Appendix 1.

Table 6.4 Landscape Value from the Environmental Statement, (which refers to criteria in the extremely important Box 5.1 of GLVIA3) with additional comments column.

Comments on the Visual assessment Tables .

Warburton Landscape Character Types and Areas (Draft)

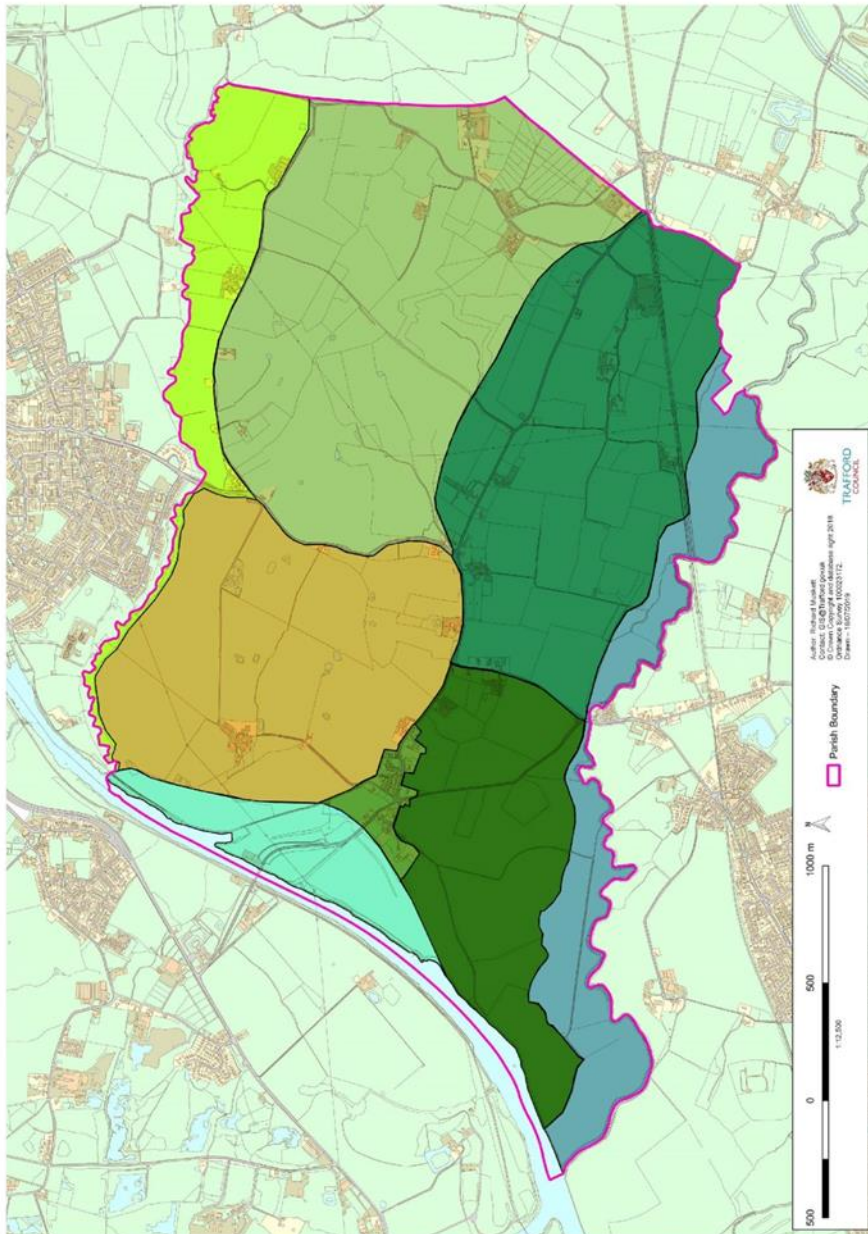
- Warburton Landscape Character Types & Areas**
- 1.0 River Meadowlands Landscape Type, comprising of:**
- 1.1 The Mersey Meadowlands Landscape Area
 - 1.2 The Balm Valley Meadowlands Landscape Area
- 2.0 Settled Sandlands Landscape Type, comprising of:**
- 2.1 The Long Ridge Landscape Area
 - 2.2 The Warburton Park Landscape Area
 - 2.3 The Town Field Landscape Area
 - 2.4 The Warburton Moss Landscape Area
 - 2.5 The Red Brook valley Landscape Area
 - 2.6 The Warburton village Landscape Area
